Change Order

Edward Devotion School Project
Town of Brookline
333 Washington Street
Brookline, MA 02245

CHANGE ORDER NUMBER: 016

(Include, where applicable, any undisputed amount attributable to previously executed Construction Change Directives)
CR009 Fill Voids Under 1913 Building SOG \$5,865; CR089 PR #15R1 - Extended Slab at K-2 Wall Footing \$3,398; CR093
PR #73 - LGMF Back-up Wall in Large Gym \$20,542; CR117 PR #85 - Shadow Box at CW28 and Added Gyp Soffit \$2,388;
CR131 Replacement of Bird Screens at Cupola per HMFH Field Report \$966; CR136 RFI #368 - Added Wall in MDF 109
\$2,434

DRAWING NUMBER  
**SKS 121**  
JOB NUMBER 401213

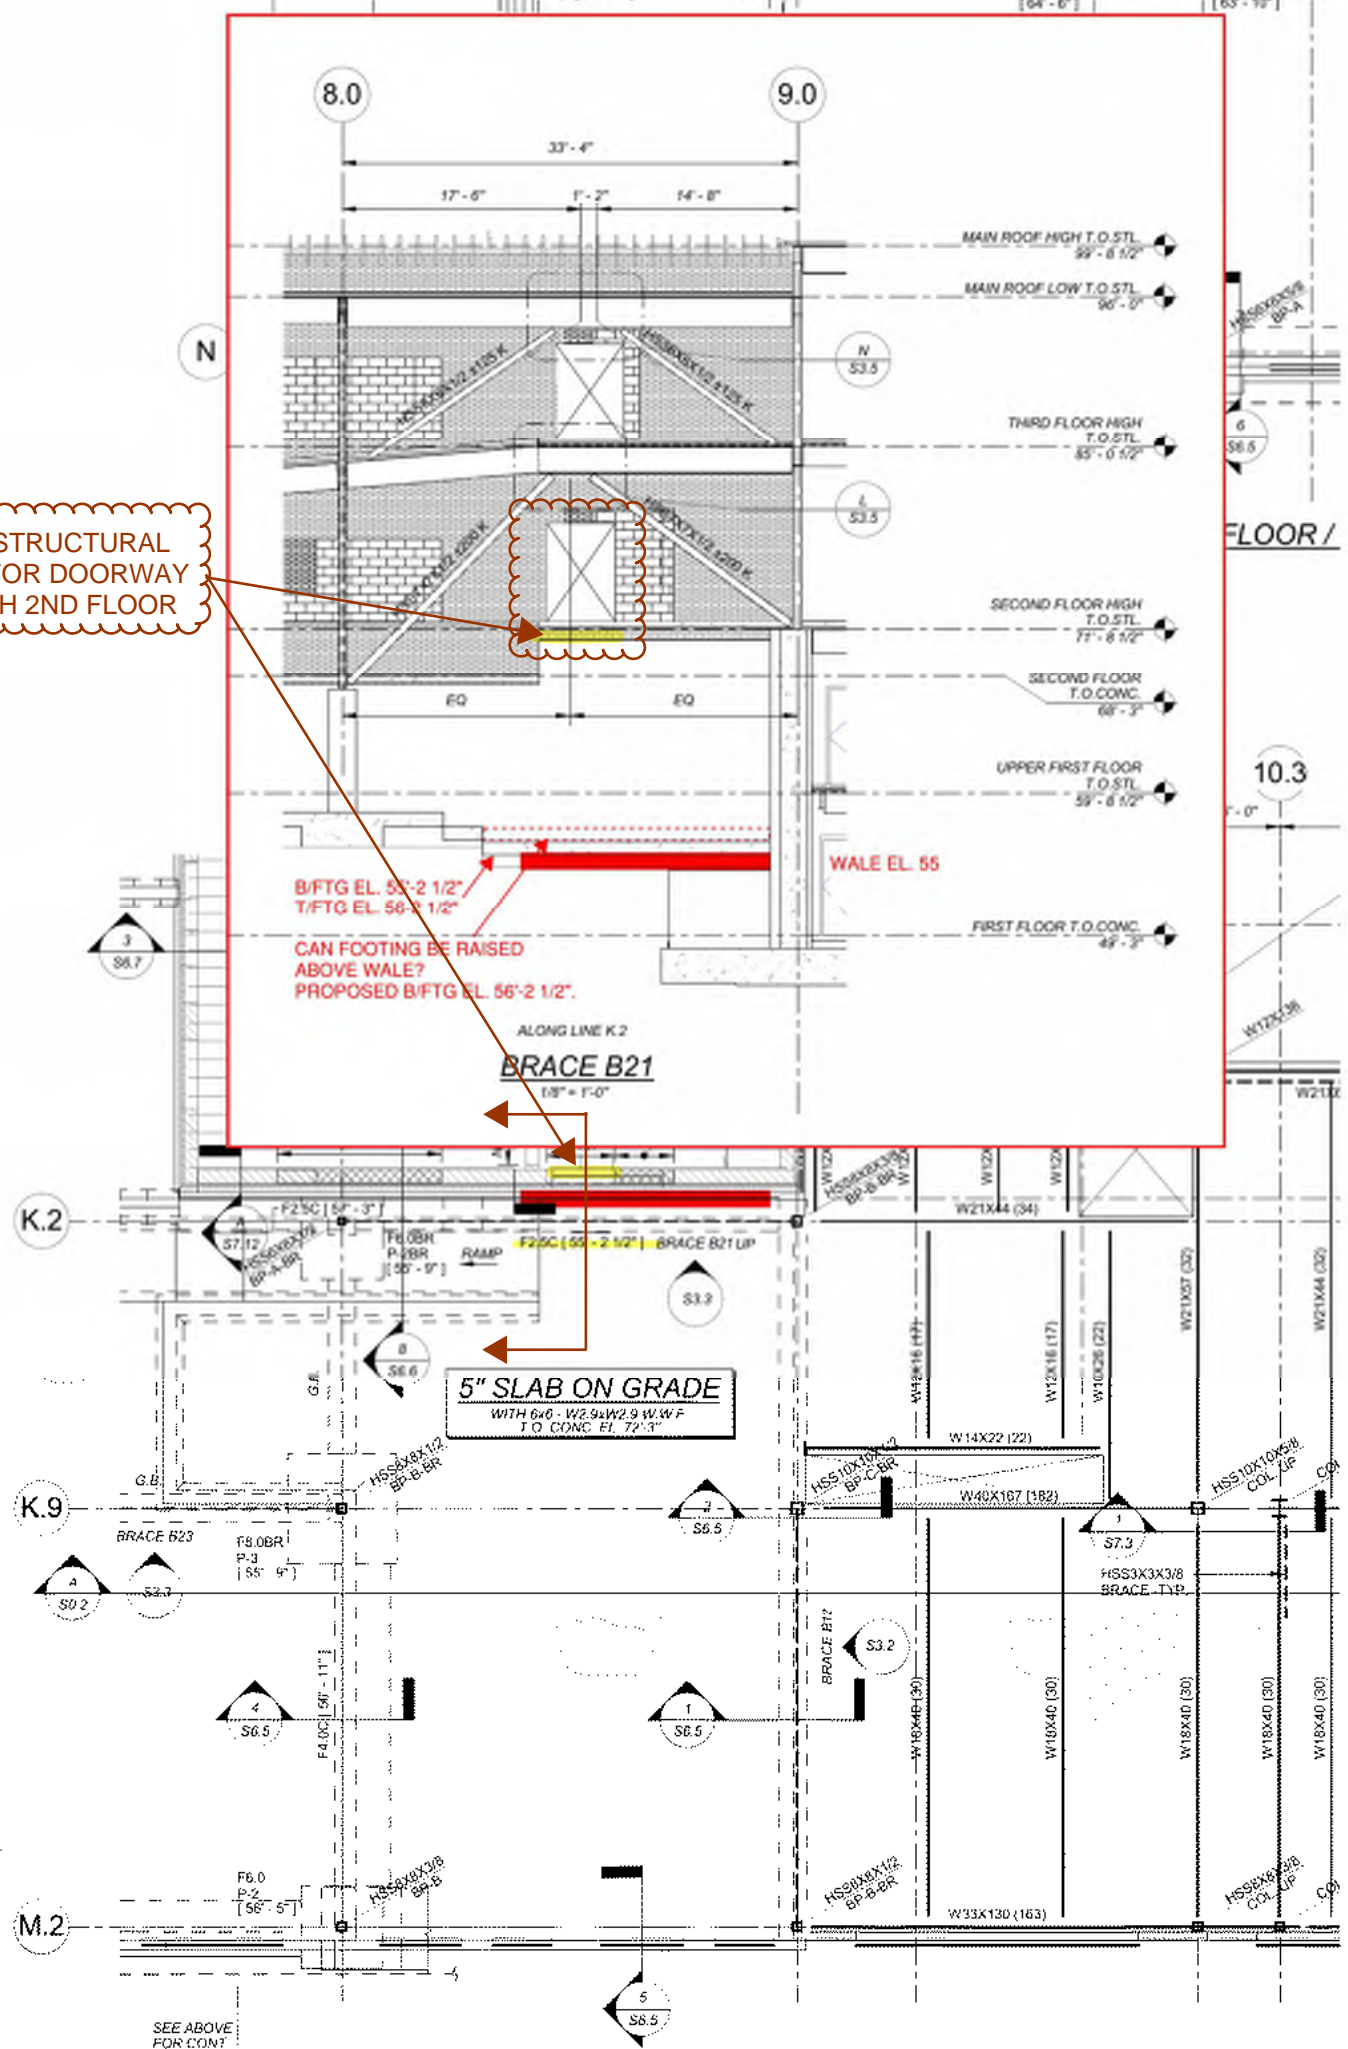
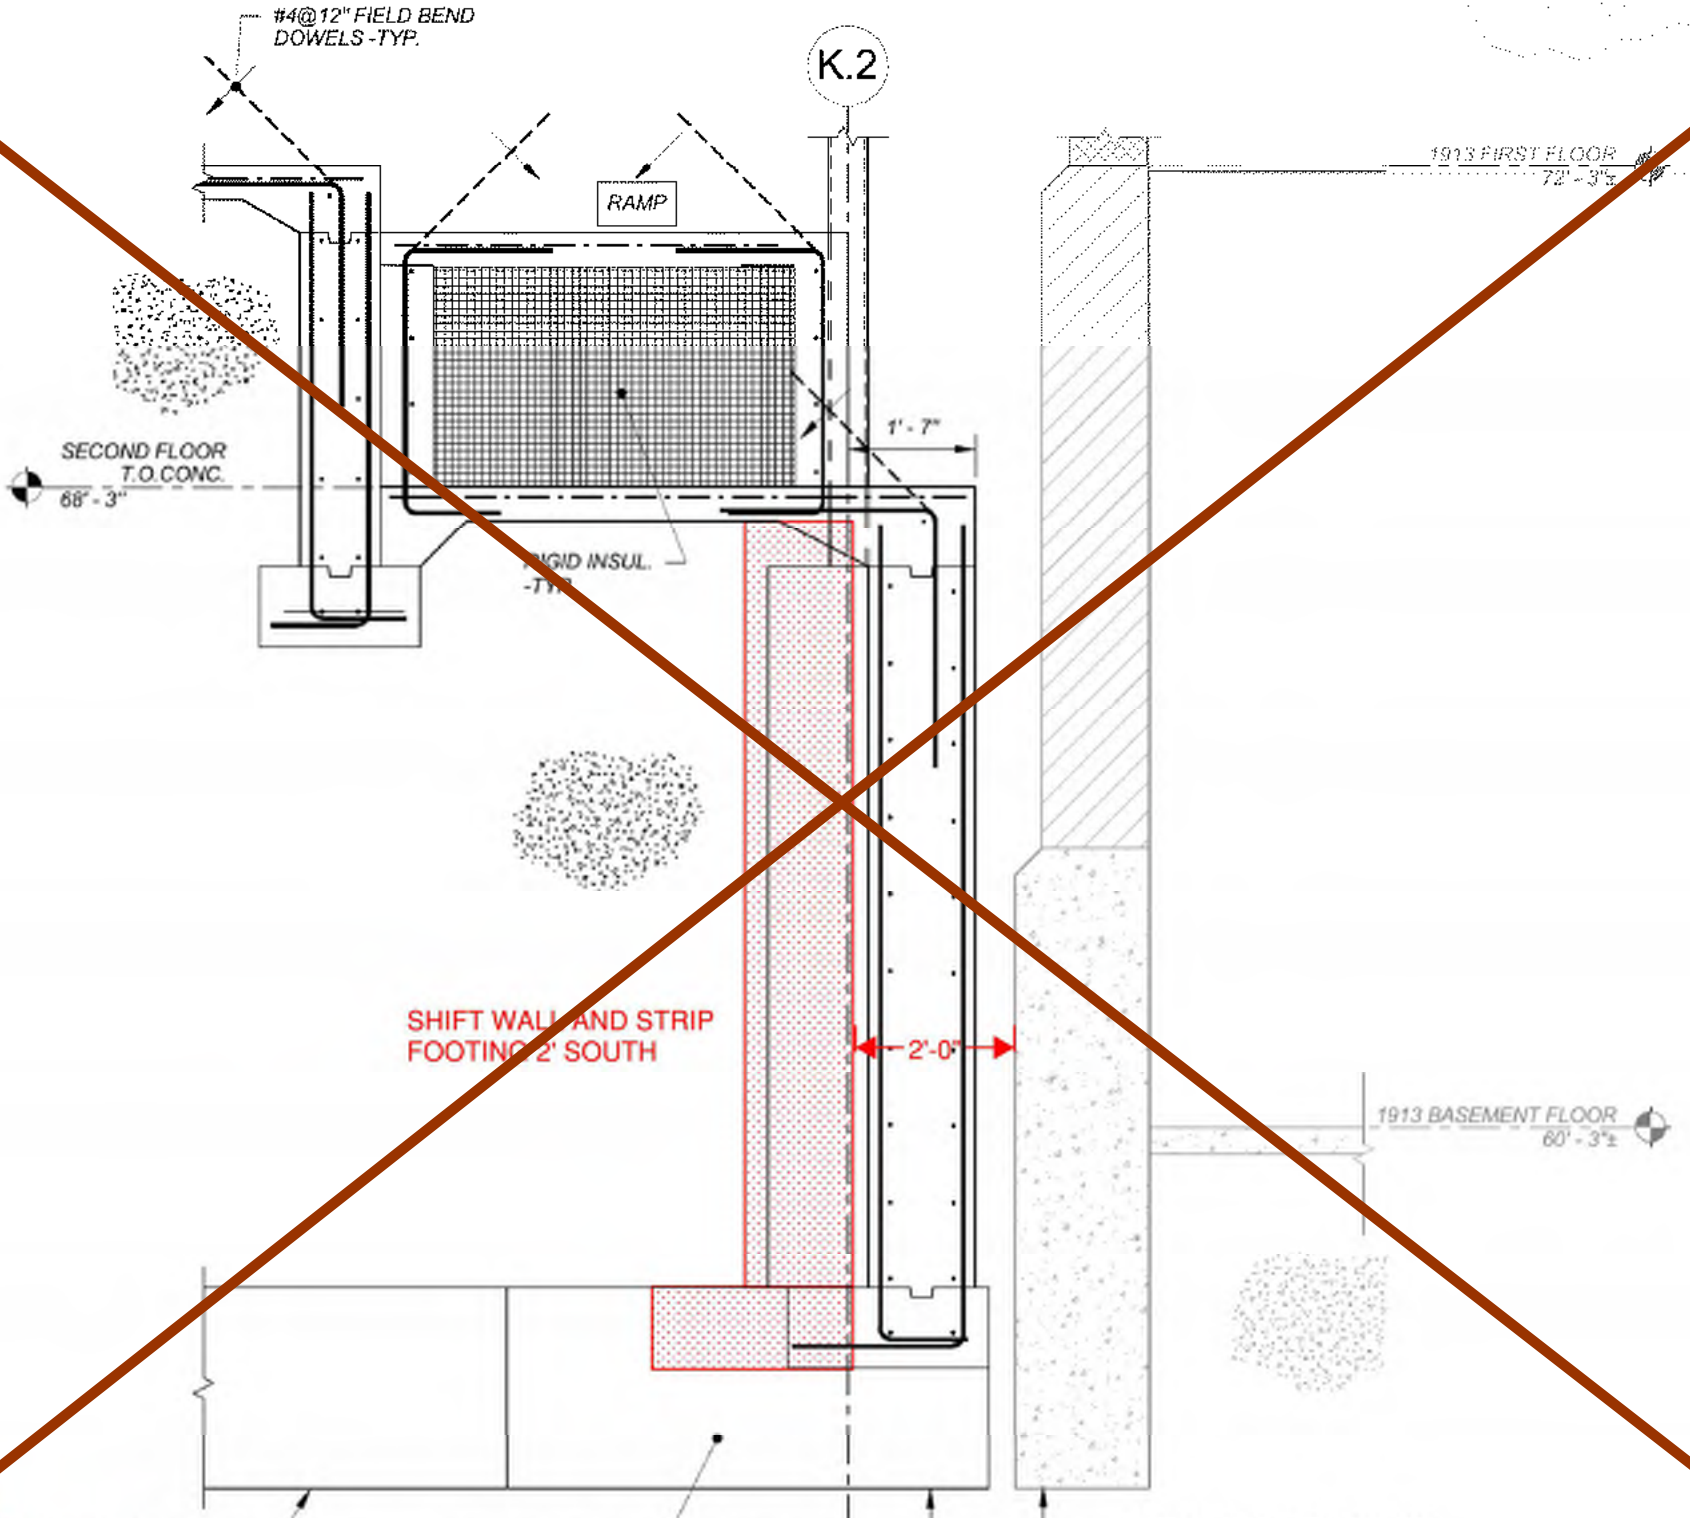
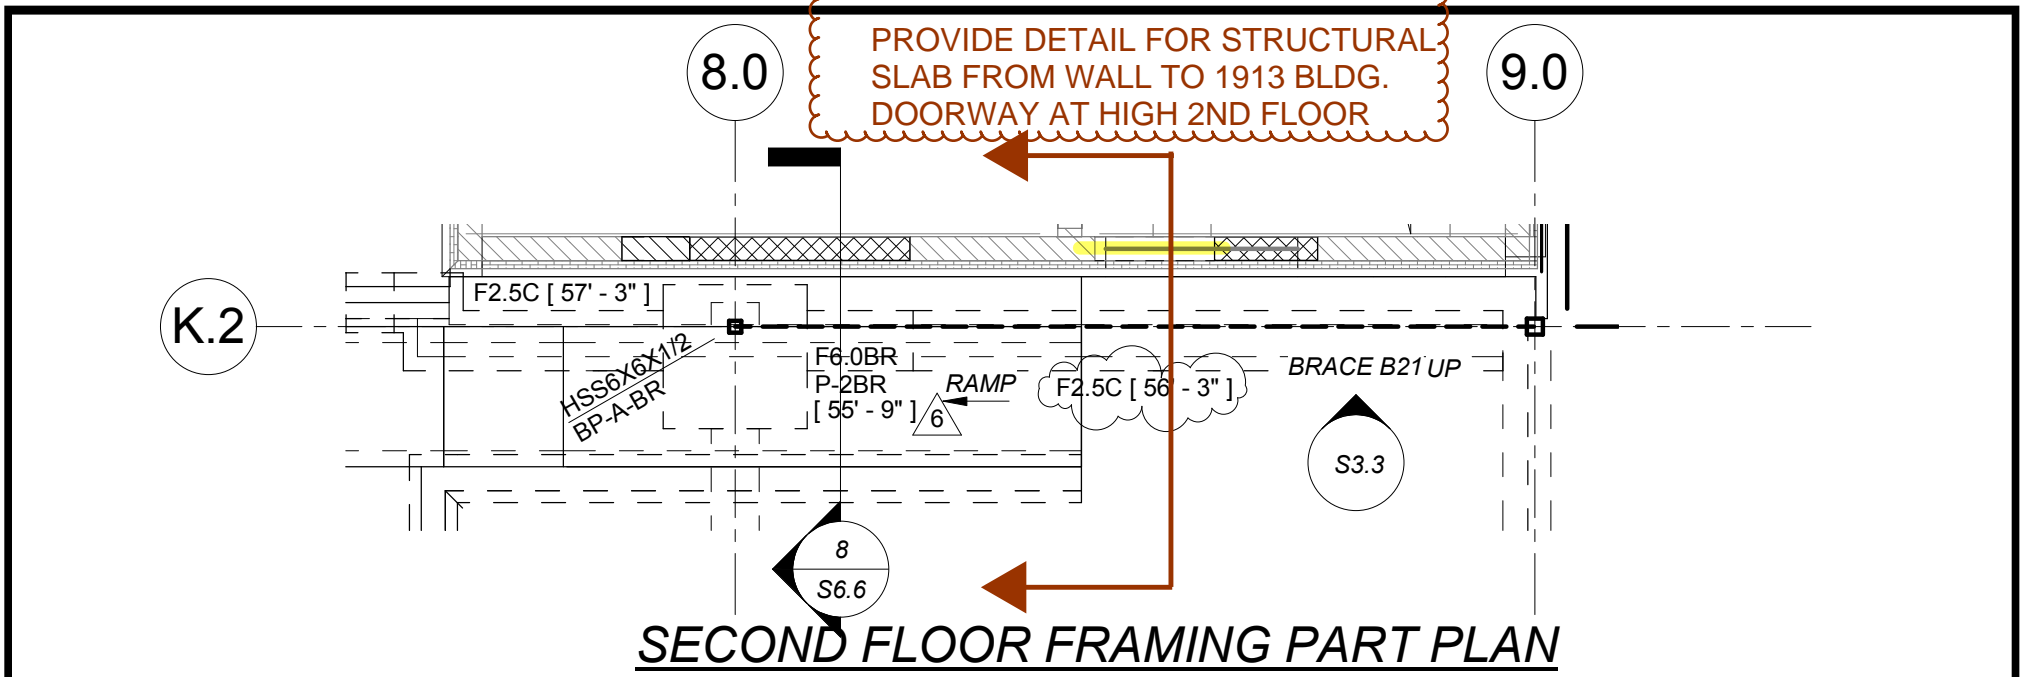
The top tier tieback wale on the south side of the 1913 building is in conflict with the proposed wall footing along column line K.2. See attached sketch.  
Please advise if the K.2 wall footing at B/Ftg EL. 55'-2 1/2" can be raised 1' to EL. 56'-2 1/2". This would put the bottom of the wall footing approximately 8" above the wale.

REVISED 12/20/2016 RESPONSE:  
PLEASE REFER TO THE ATTACHED SKS-121.
